ADDENDUM #2
January 08, 2021

PROJECT: **USDA Sewer System Improvements – Contract B – Town Branch Interceptor**

OWNER: City of Thomaston

SHEET NO: C4.0

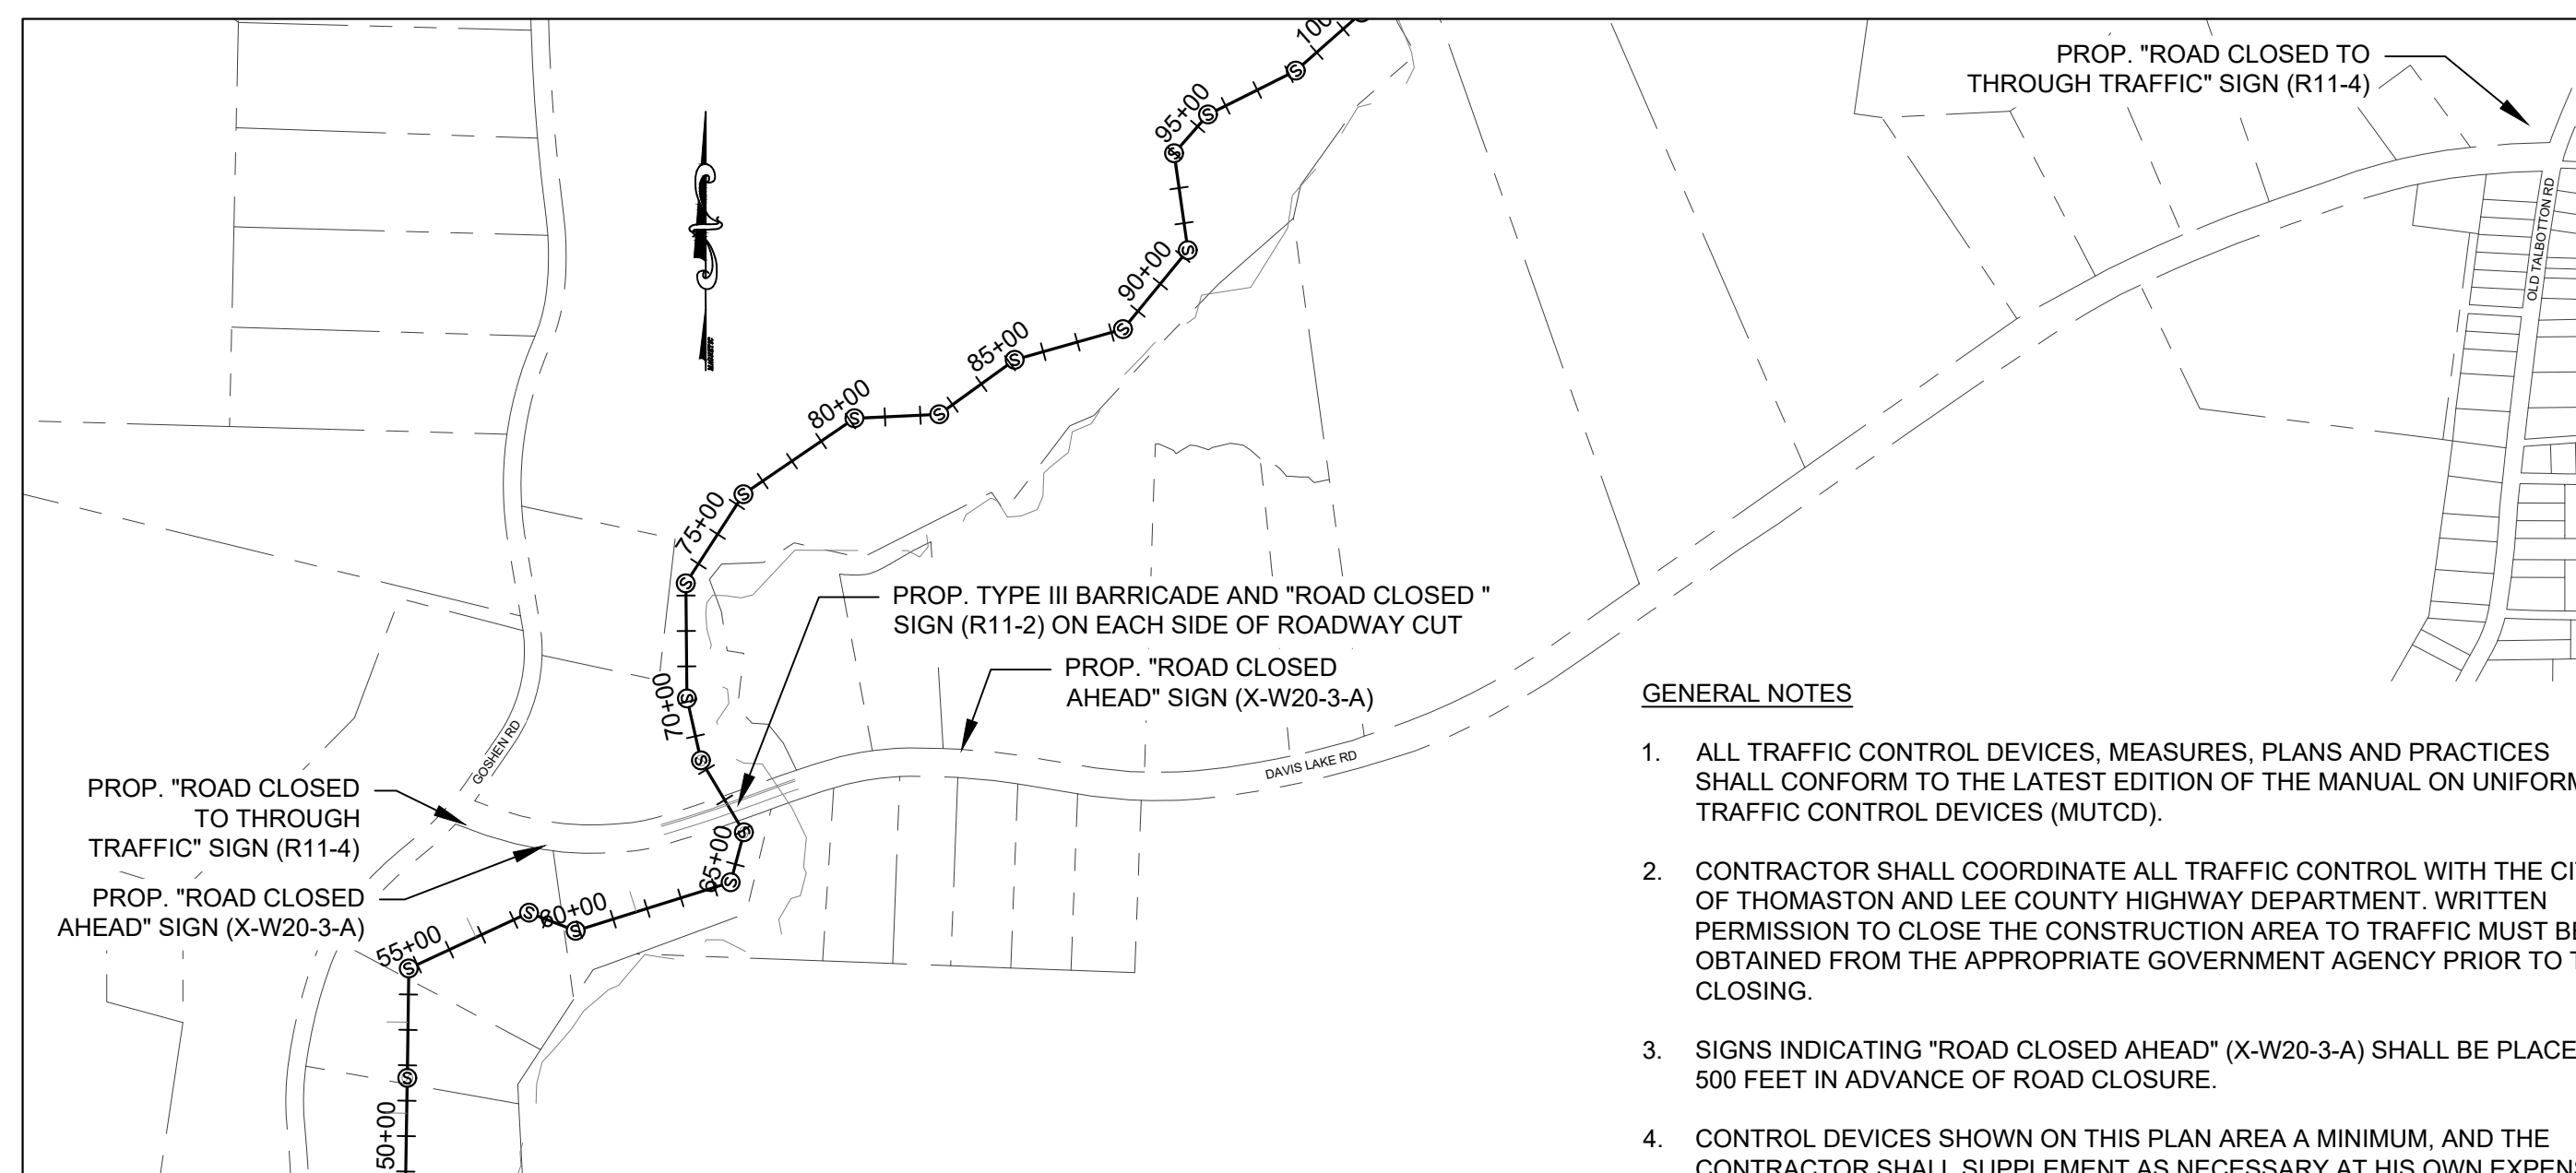
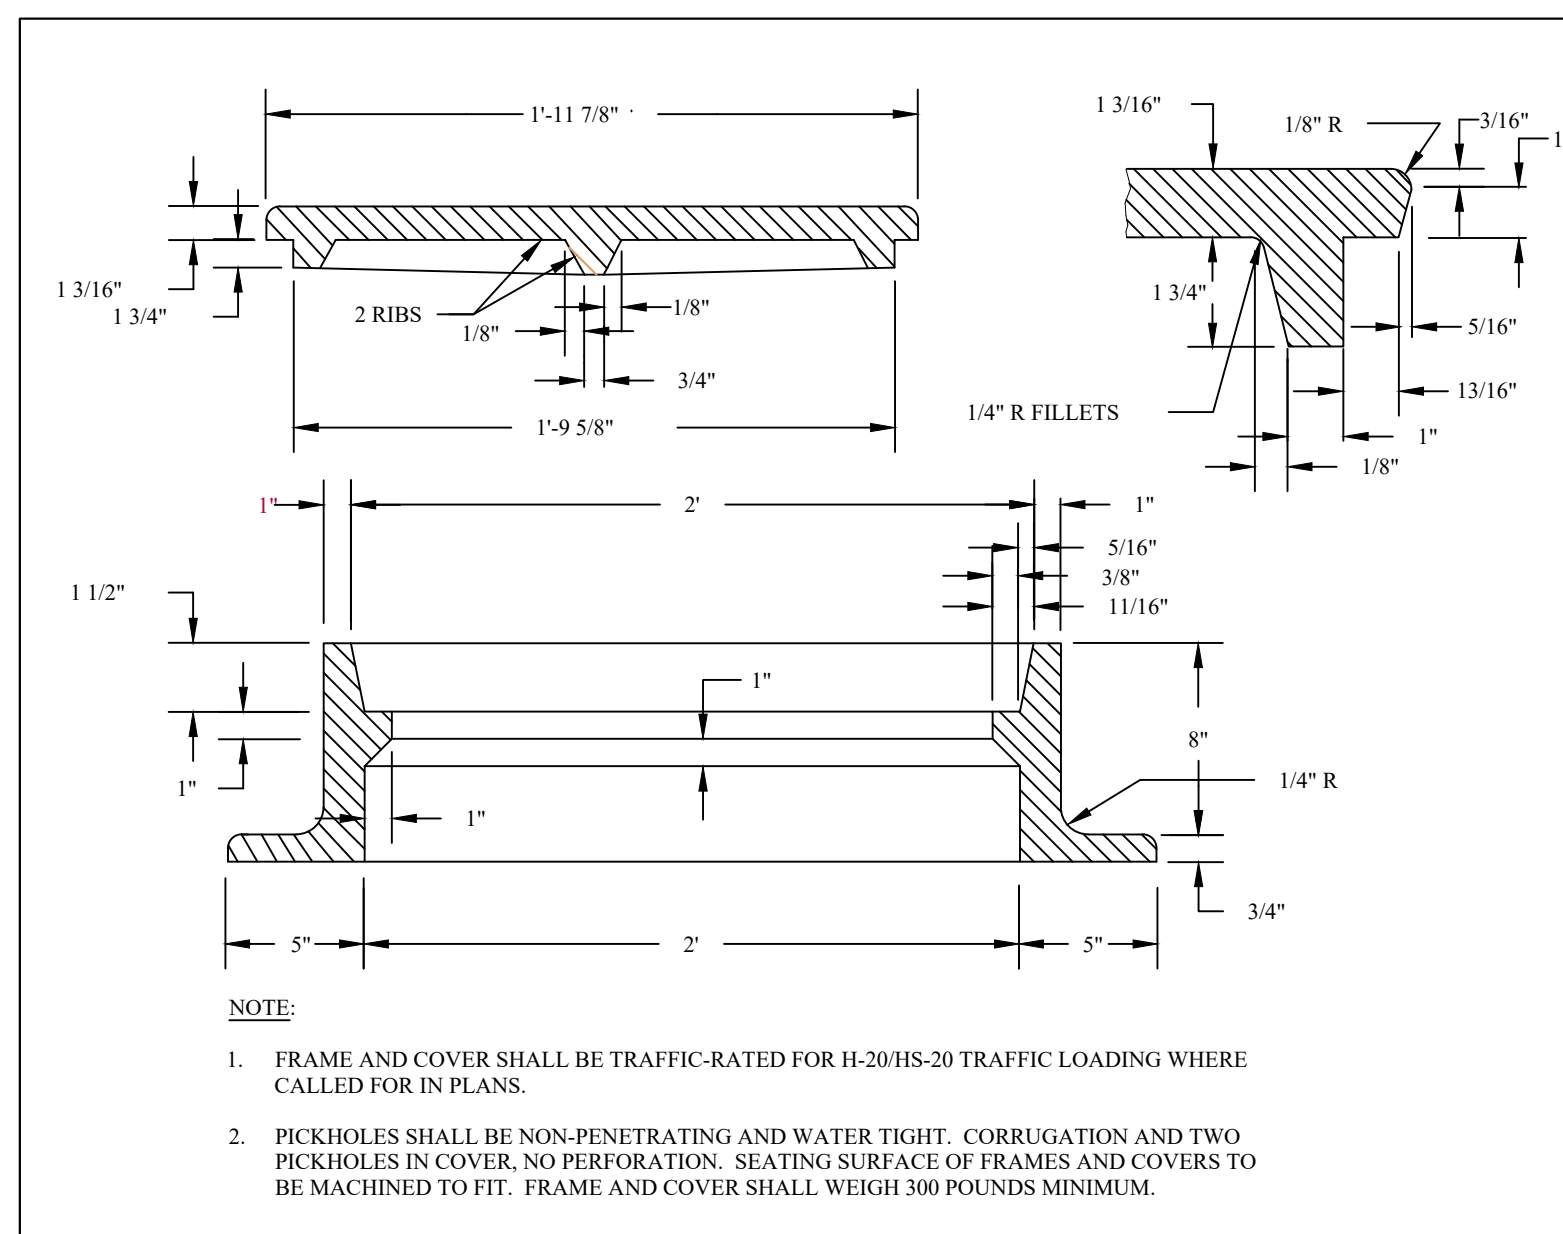
- a. The service pipe connection detail has been modified. See attached plans.
